Proposal for the 07 series of amendments to Regulation No. 48 (Installation of lighting and light-signalling devices)

Note: The text reproduced below was prepared by the expert from Poland to improve the OICA and GTB proposal in ECE/TRANS/WP.29/GRE/2015/5 introducing new criteria on the automatic levelling of headlamps based on the GTB glare and visibility studies. The modifications to the proposed text are marked in blue bold for new Polish changes or orange strikethrough for deleted characters of the GTB-OICA proposal.

(Option 1)

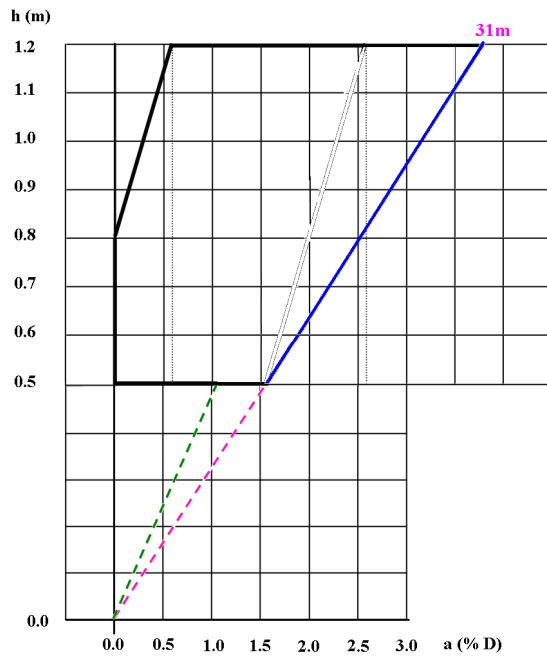
h = 0.5 m: from 0.0 per cent to -1.6 per cent;
h = 0.8 m: from 0.0 per cent to -2.0 per cent;
h = 1.2 m: from -0.6 per cent to ~~-2.6~~ -3.8 per cent.

Commenté [tt1]: To keep GTB proposed 31 m value of the road illumination distance.

(Option 2)

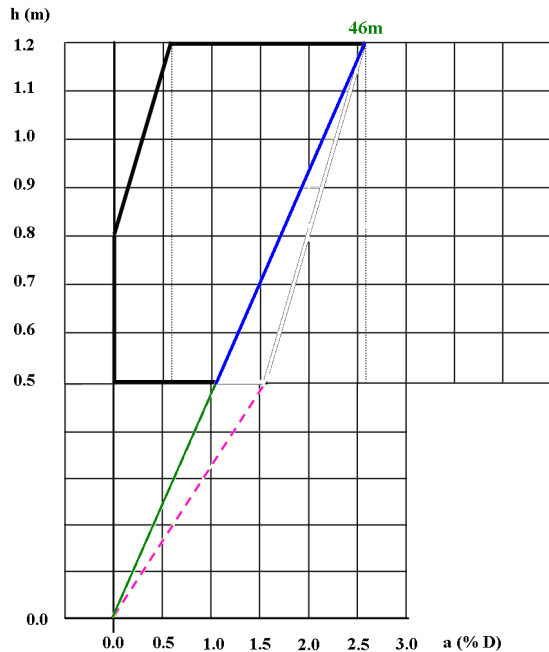
[h = 0.5 m: from 0.0 per cent to -1.6-1.1 per cent;
h = 0.8 m: from 0.0 per cent to -2.0 per cent;
h = 1.2 m: from -0.6 per cent to -2.6 per cent]

Commenté [tt2]: Or alternatively to keep GTB proposed 46 m value of the road illumination distance. Any other minimum road illumination distance can be easily chosen. **Poland recommend 50 m.**

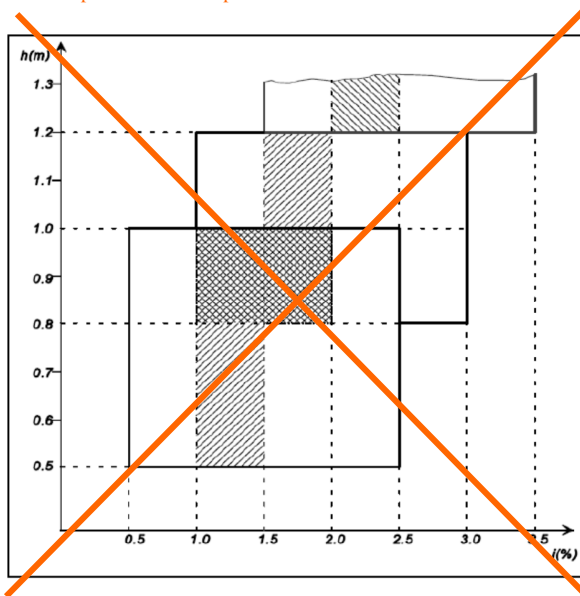
~~The above limits and the initial aiming values are summarised in the diagram below:~~
